Safety Evaluation Report of License Amendment Request, dated September 24, 2018, United Nuclear Corporation (UNC) submitted a request to the U.S. Nuclear Regulatory Commission (NRC) to amend its Source Materials License No. SUA-1475 for the former UNC Church Rock uranium mill and tailings site under the requirements specified in Title 10 of the Code of Federal Regulations (10 CFR), Part 40, Domestic Licensing of Source Material

Materials License No. SUA-1475

Docket No. 040-08907

September 30, 2020

Figure 5: Proposed profile of the future repository and disposal cell in a borrow pit area.

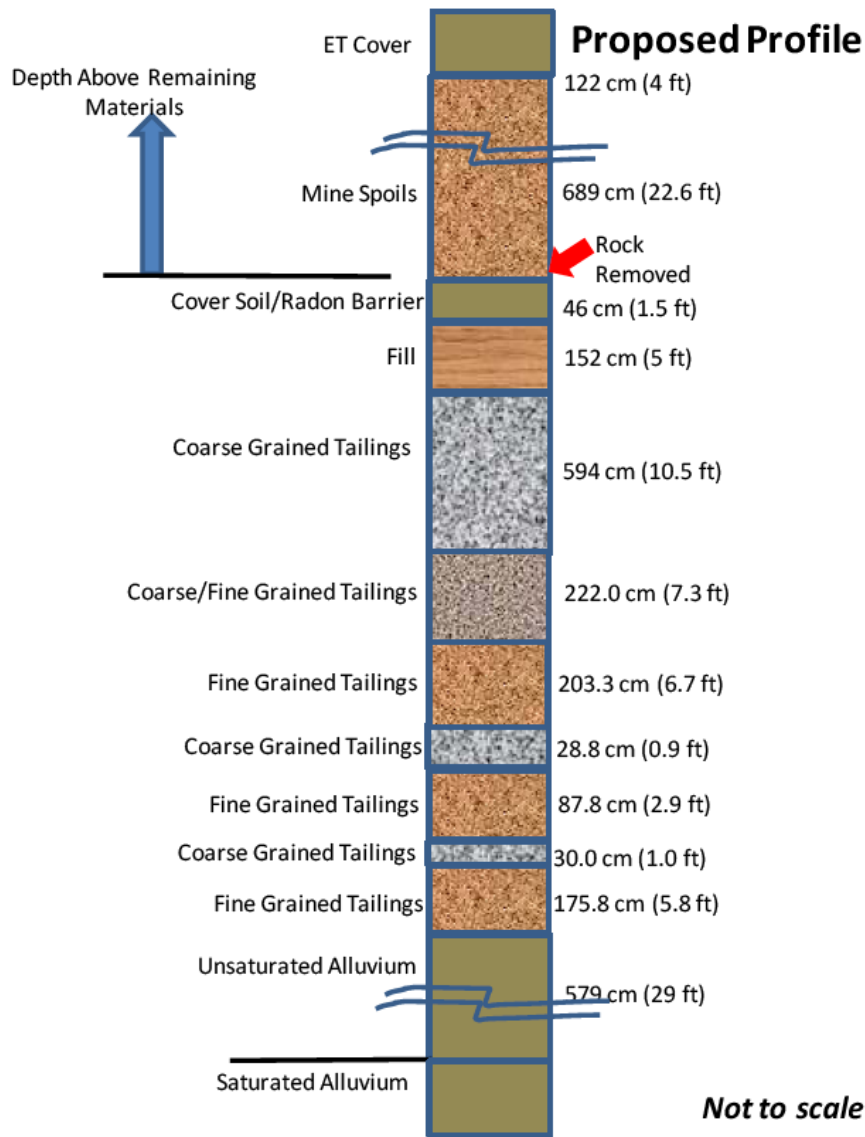
Appendix Y (UNC, 2018) of the LAR contains the results of the licensee's analysis of the potential effect of the added weight of the mine waste on the underlying mill tailings and subsequently on the underlying groundwater. Mine waste will be disposed of in a repository designed within the footprint of the existing tailings impoundment at the mill site. Rocks and rip-rap on top of the current cover at the Church Rock site will be removed before placement of the mine waste and later reused at the surface. The original disposal cells with tailings will not be altered and the original radon barrier will also be left in place. Figure 5 shows a profile of the future repository and disposal cell in a borrow pit area (Borrow Pit #1). Placement of the mine spoils and subsequent ET cover components will place added weight, and thus stress, on the existing tailings material originally placed within the existing impoundment. Appendix Y states that there is a relatively small reduction in porosity in the tailings due to the added weight on the existing impoundment and that the coarse and fine tailings become fully saturated in some of the profiles. However, the licensee states there is no increase in flux into the underlying groundwater from the tailings and therefore no drainage impact into the underlying groundwater. Similar to the UNSAT-H simulation results performed in Appendix G, Attachment G.7, findings from these sensitivity analyses show that the new ET cover components prevent flux while the existing cover did allow percolation into the disposal cell, but no downward flux from the base of the alluvium.

Figure 6: Hypothetical soil water characteristic curves before and after consolidation.

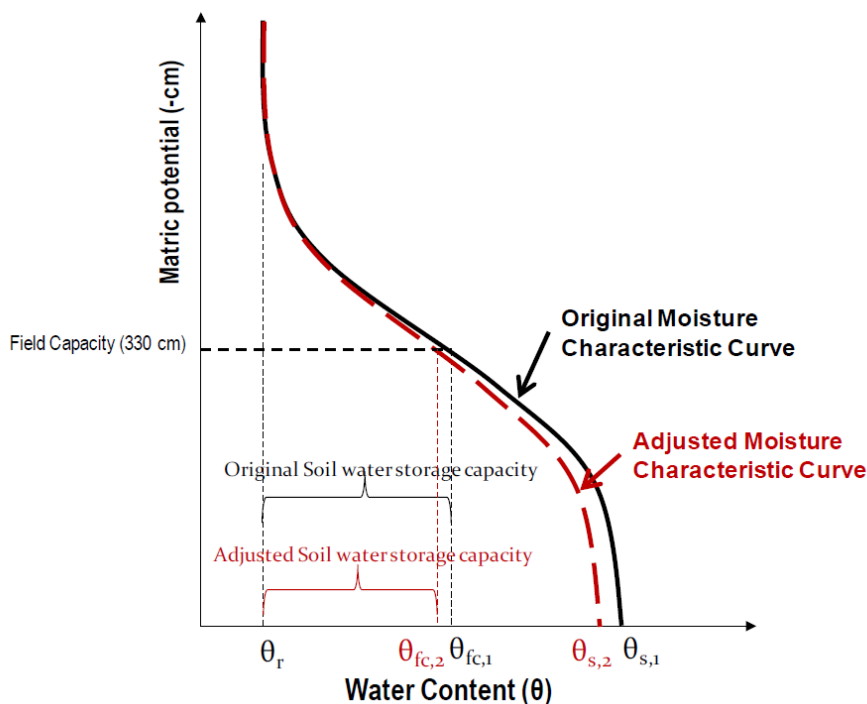
Section 7 in Appendix Y discusses the boundary condition at the base of the alluvium being a unit gradient boundary condition and therefore “forcing drainage based on steady state conditions at the bottom node” and that it “does not necessarily mean there is actually drainage from the alluvium.” A unit gradient lower boundary condition assumes that free drainage exists in the vertical direction, i.e., downward flow due to gravity, and it implies that water that passes downward across the boundary does not return to the simulated domain. This is a standard boundary condition for unsaturated flow models besides a fixed water table or seepage boundary. Drainage water is part of the water budget of the model as seen in the tables of Appendix A of Appendix Y and should be accepted as drainage since water not bound to the soil particles will be pulled downward by gravity.

Figure 8: Storage and percolation and water contents at various depths of the ET cover

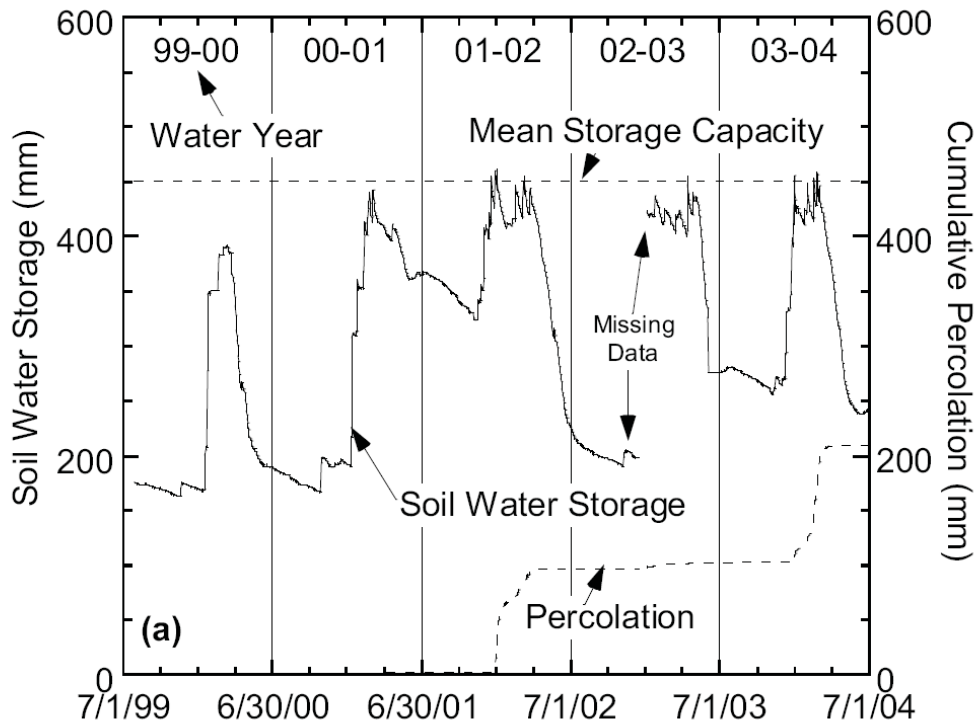
NUREG/CR-7028 (NRC, 2011) provided an example of how unexpected phenomena can lead to unexpected results. As given in NUREG/CR-7028, data from an ET cover in Sacramento, CA was intended to transmit no more than 3 mm/yr (0.1 in/yr) of percolation; however, approximately 100 mm (4 in) of percolation was recorded to have been transmitted (see Figure 8 below). Water stored during the previous winter was not completely removed so that the cover had inadequate soil water storage capacity the following winters. Perennial vegetation initially established on the cover was unintentionally succeeded by annual species that had a lower wilting point potential (higher water content at the wilting point), shallower roots, and a shorter period of active transpiration, thereby allowing more water to stay in the water storage layer and eventually move downwards.

Based on the issues discussed in this section, the NRC staff concludes that the uncertainty associated with the UNSAT-H infiltration modeling results remains too large. This is not to say that the results are incorrect; future measurements or data may show that the flux predicted by the UNSAT-H simulations are correct. However, currently, the uncertainty has not been bounded and there is insufficient model support to unequivocally claim that no net seepage through the mine waste and mill tailings will ever occur for the performance period. Unforeseen, slow or fast paced detrimental events do happen in the natural world and the resulting increased parameter ranges may not have been bounded by the ranges used in the UNSAT-H models.

Figure 9: Church Rock location within the region of Arizona State PMP Study

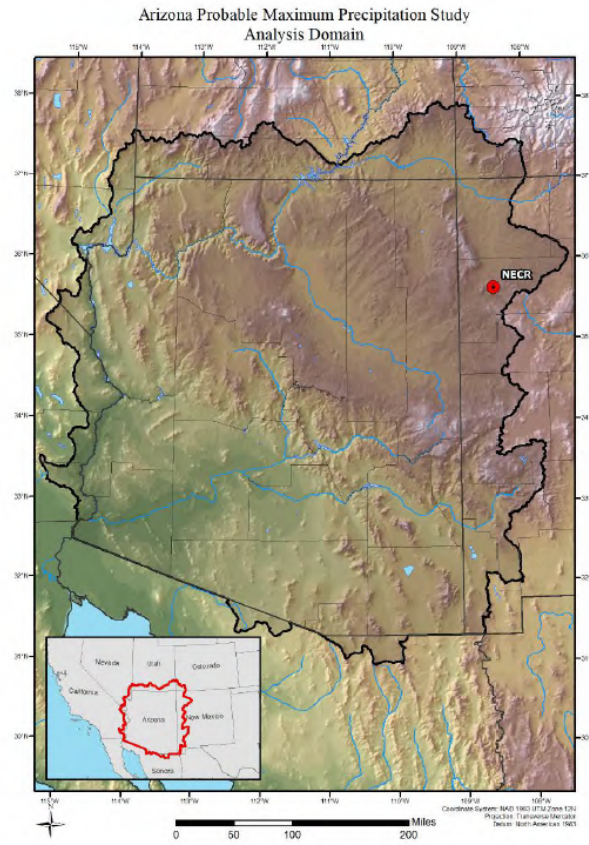
Figure 9 below shows that the location of the Church Rock site is within the region of the Arizona State PMP study.

For the above reasons, the NRC staff concludes that licensee’s decision to use an updated PMP is justified for the LAR (Figure 9). As stated in Attachment I.1 of the LAR, the ADWR PMP tool produces gridded PMP values using a grid spacing of 2.5 square miles at 1-hour intervals for storm durations ranging from 1 to 6 hours for the Church Rock basin. In general, the ADWR PMP study follows many procedures used in HMR development. Consistent with the HMRs and other PMP approaches, the Arizona state PMP followed a storm-based approach, by which PMP is estimated based on historical storm observations, as well as updated storm selection, updated observed storm precipitation data, storm representative dew point selection and moisture maximization, dew point climatology and moisture adjustment, and terrain adjustment.

Figure 10: PMP temporal accumulations for various durations

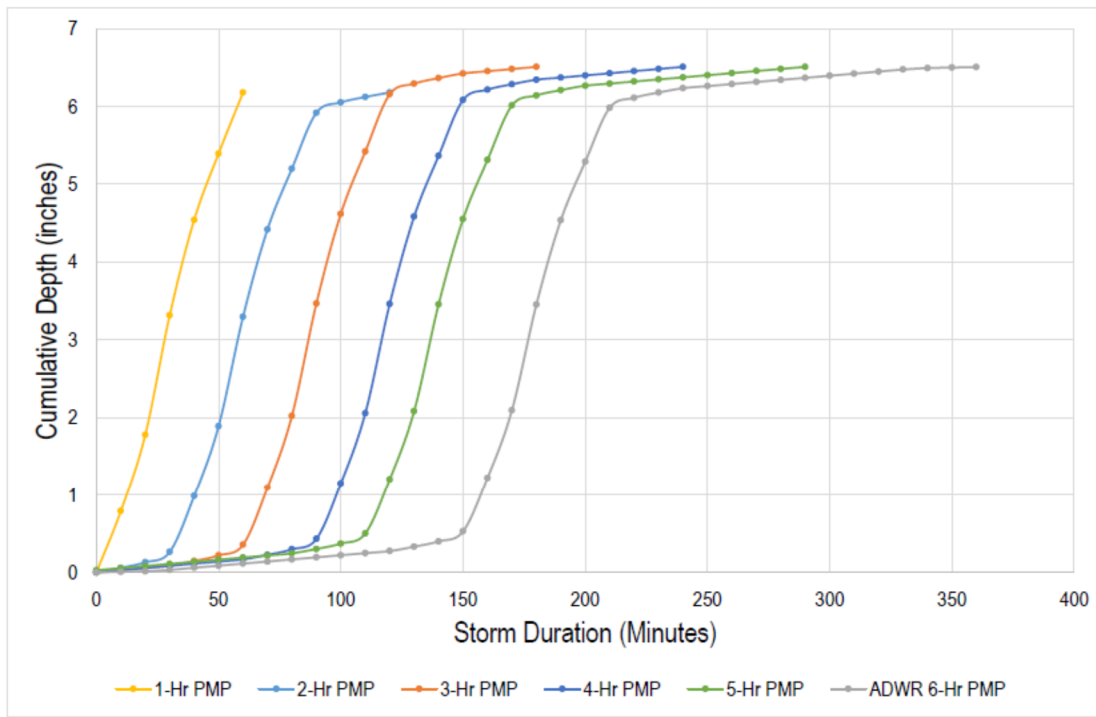
As presented in Figure 10 below, the licensee’s intensity-ratio method is to distribute a 1-hour peak precipitation at the middle of temporal distribution of other PMP events as the same pattern of the 1-hour peak precipitation within the 6-hour PMP event.

Figure 11: Location of the proposed riprap chute in the Pipeline Arroyo and the existing Branch Swale H and two evaporation ponds

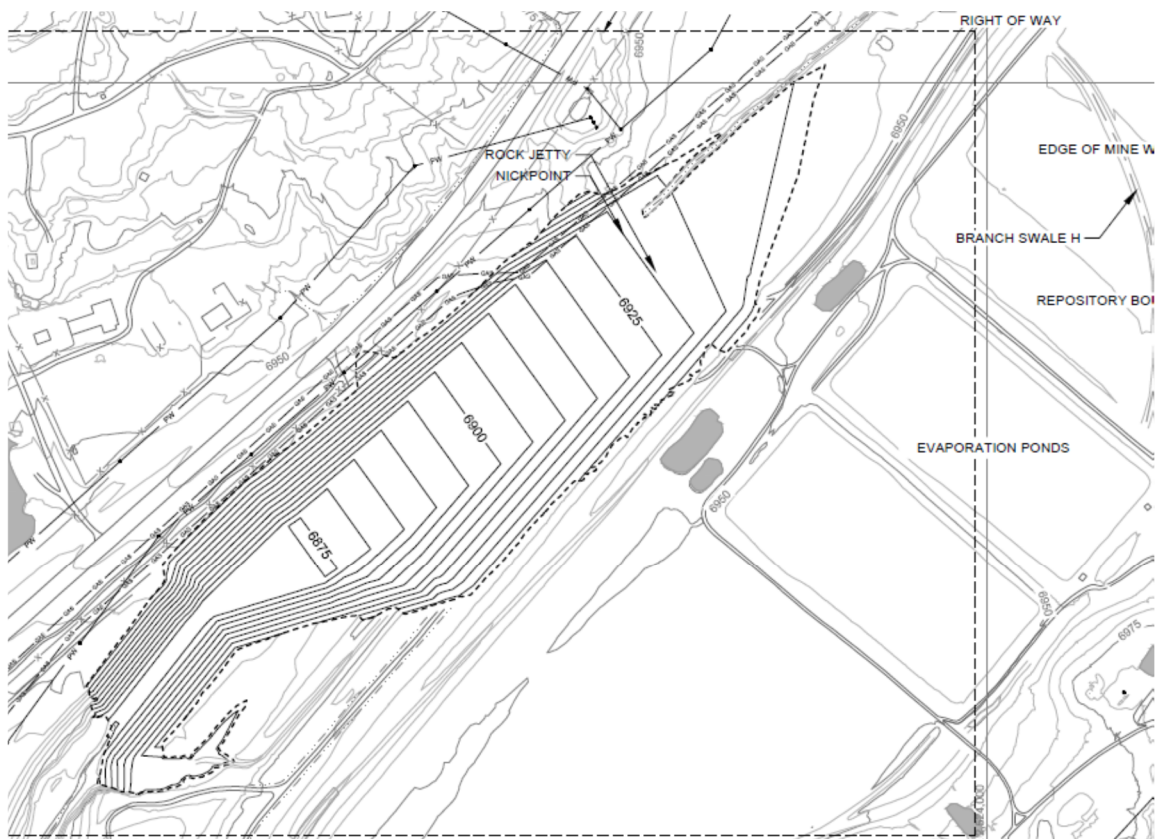
The licensee used a three-dimensional model to simulate steady flow conditions within the riprap rock chute and the sunken basin for multiple flood events. The simulation results indicate that the PMF produces a maximum flow speed of 27 ft/s near the right bank (northern side) of the riprap chute (Figure 3 of Supplement I.7.1 of Attachment I.7 of Appendix I, Volume I). The licensee used this flow velocity as a main velocity to design the riprap rock protection for the chute and the sunken basin. The licensee selected other velocities lower than 27 ft/s as secondary options to design riprap rock protection for low flow velocity areas.

Figure 3 of Attachment I.7 shows velocities at cross-section A-A range from about 27 to 5 feet per second. Although a straight, prismatic channel would be expected to have a more uniform velocity distribution across the section in which the velocity peak occurs at the center of the section, this riprap chute is not a straight, prismatic channel because the cross-sectional area is contracting along the left (southern) bank as flow moves down the chute as shown in Figure 1 of Attachment I.7. In this asymmetric contraction of flow, the velocity is expected to be greatest along the right (northern) side of the channel where flows have the streamline of least resistance and the velocity would be expected to stagnate along streamlines where the flow is obstructed. This asymmetry in the geometry was the reason that the 3-dimensional Computational Fluid Dynamics (Flow3D) model was used to model this structure.

3. Observed high flow velocities larger than 3 ft/s (Figures 2 and 3; Design Drawing 09-10) in some local areas without riprap rock protections.

Based on the licensee's response, the NRC staff concludes that riprap rock layer will protect the downstream apron as rock will be placed in the areas of the chute with higher flow velocities. The NRC staff validated the extended riprap layer based on reviewing the licensee's submittal of the revised design Drawings 09-09 through 09-11 (ML19315A011).

In design drawings 9-09, 9-10, and 9-11, Stantec extended the apron length to the riprap basin to 380 feet. This is sufficient to provide erosion protection beyond the length of the hydraulic jump. The revised drawings are included as Attachment 3 to this submittal.

Figure 12: Layout of drainage system in the proposed repository area of the mill site

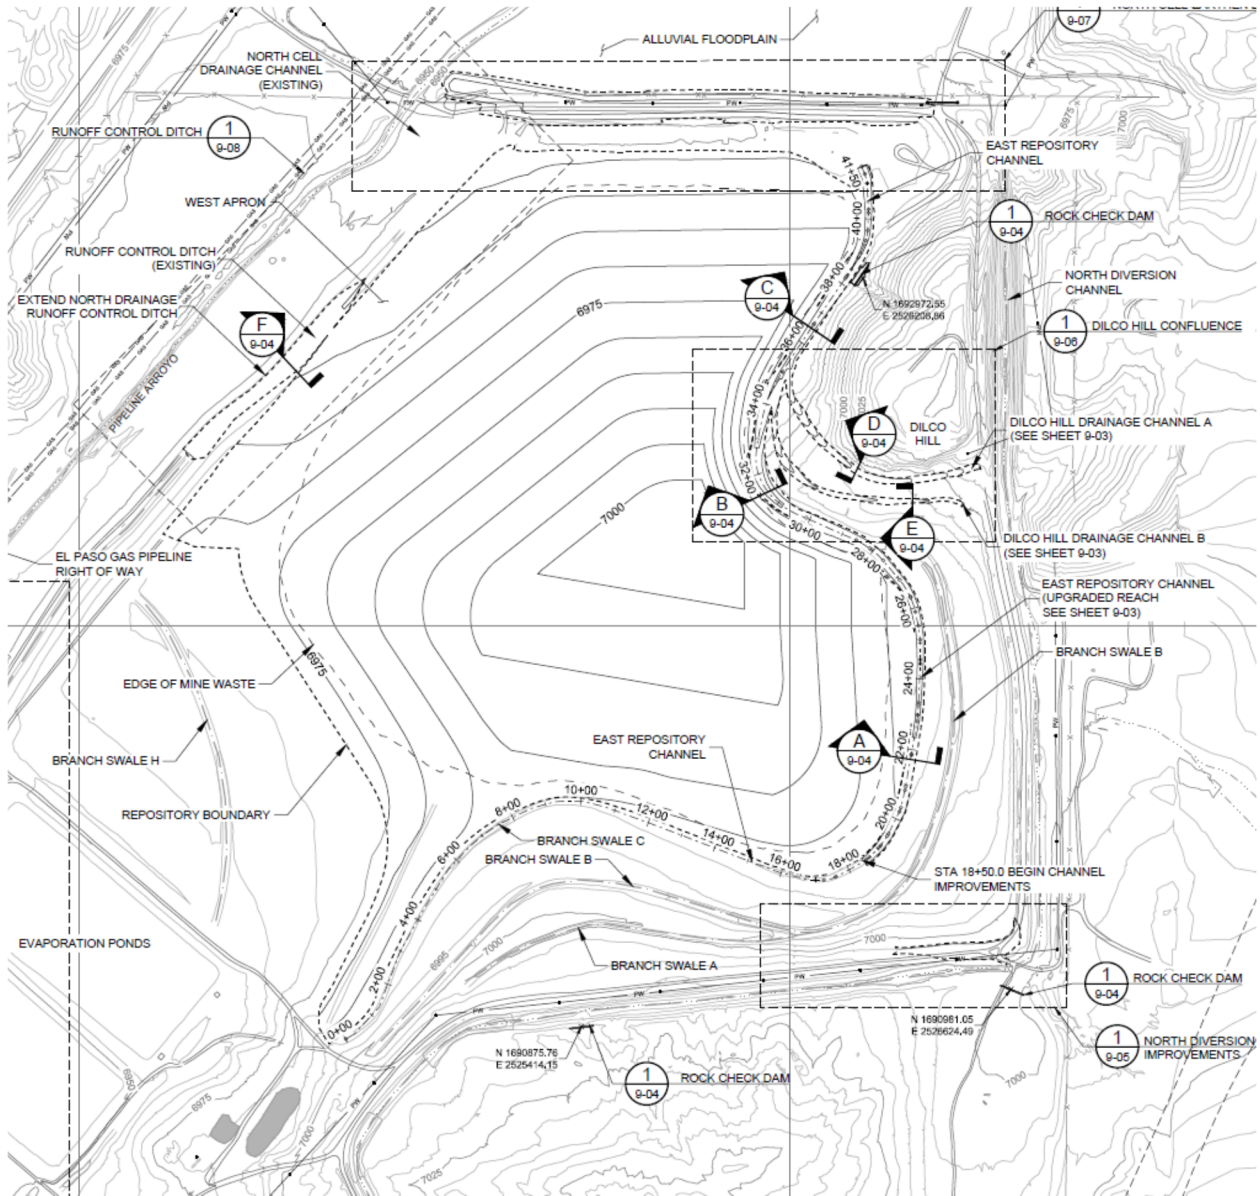
The North Cell Drainage Channel and Northern Alluvial Area (see upper right corner of Figure 12 of this SER) are adjacent to the northern boundary of the north cell of the Tailing Disposal Area (TDA). The channel and its alluvial flood plain discharge flood flows into the upstream

The Repository area will be overlaid by a proposed mine waste layer and a cover layer as part of the Removal Action (RA) plan. The proposed lower East Repository Channel will follow the existing path of the upper reach of the North Cell Drainage Channel. The licensee presented the channel alignment, channel profiles, and typical channel cross sections in the Design Drawings 9-02 through 9-06 (Volume II Design Drawings of the LAR, ML18267A348) for the lower East Repository Channel and the two Dilco Hill Channels A and B. The Design Drawing 9-02 also shows the locations of Branch Swale H, which has no outlet (see middle left edge of Figure 12), and Runoff Control Ditch, which connects to a natural drainage downstream along the north-west edge of the mill site repository area.
